Technical Service Bulletin

Subject: BLIND SPOT MONITORING (BSM) FALSE DETECTION AFTER COLD START	Bulletin No.: 15-001/22
	Last Issued : 01/12/2022

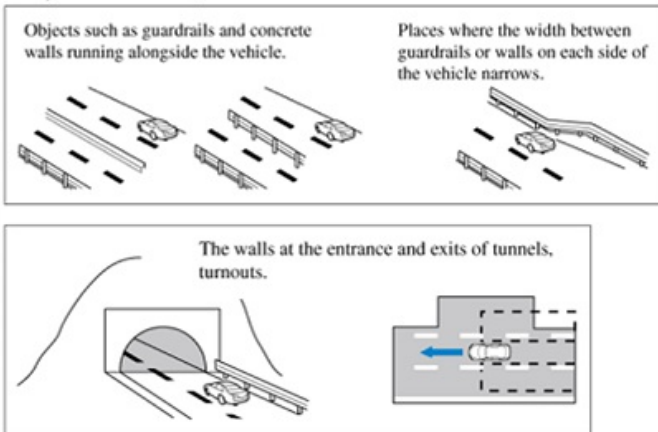
Some vehicles equipped with Blind Spot Monitoring (BSM) may experience a BSM indicator light on the outer door mirror, even if there is no vehicle in the alert (blind spot) area.

Due to BSM control module production variances, a false detection may occur in some units when the BSM temperature in the control module has not yet reached normal operating temperature. To eliminate this concern, the control logic of the BSM control module has been modified.

1. Verify the customer concern.
2. Replace the BSM control module of affected side with a modified one according to MGSS online BLIND SPOT MONITORING (BSM) CONTROL MODULE REMOVAL/INSTALLATION.
